← 199 Windy Farm Ln  
Fuquay Varina, NC

← Slab Detail

← Framing Detail

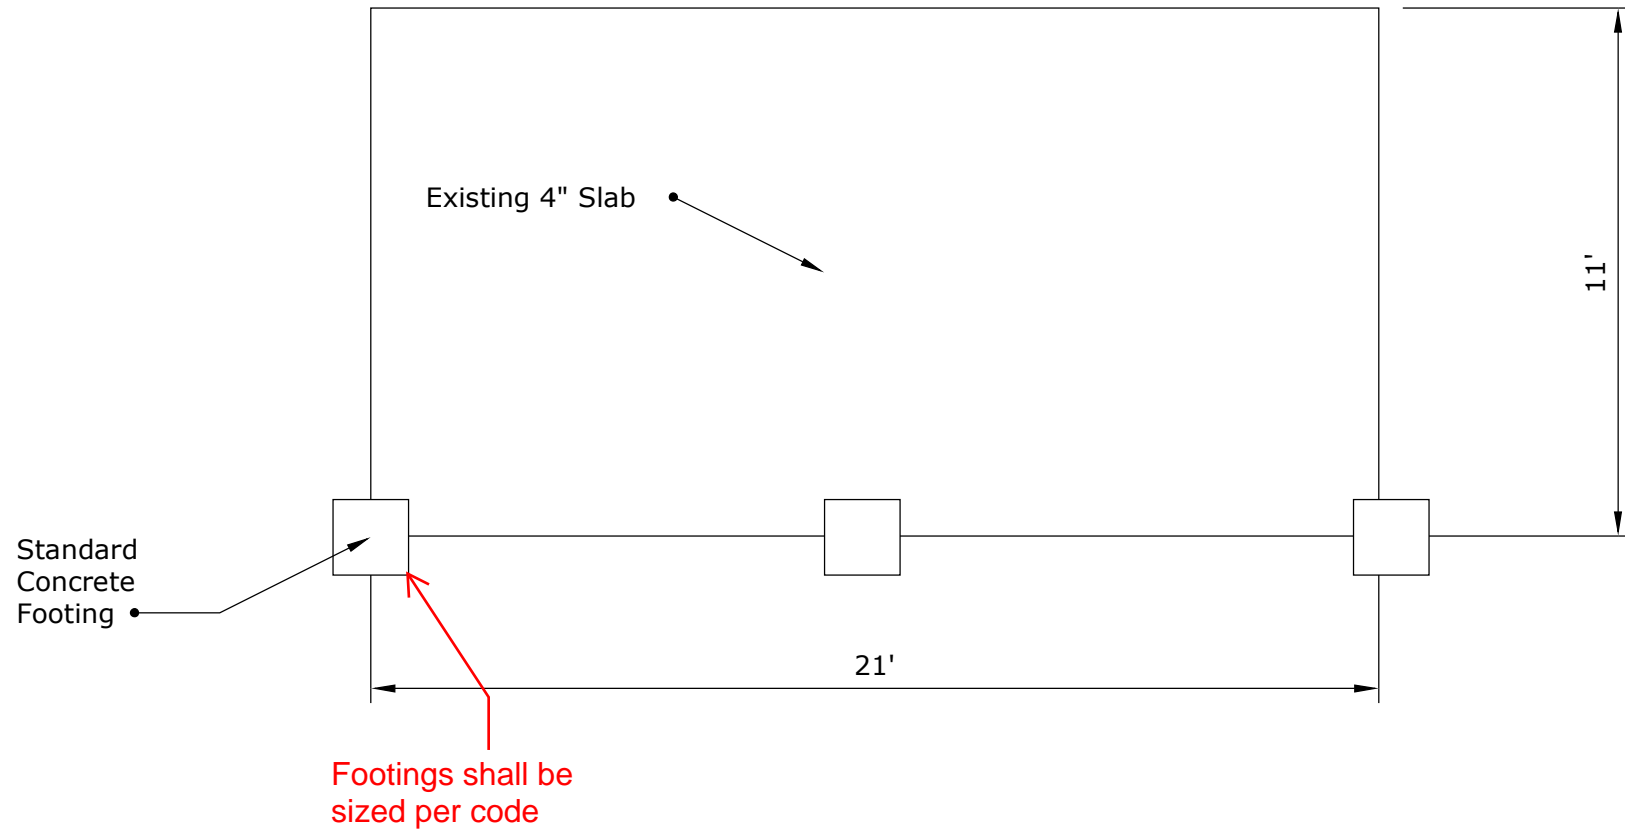
Provide collar ties in  
upper 1/3 of rafter  
span

All 3 beams shall be  
anchored to existing  
framing
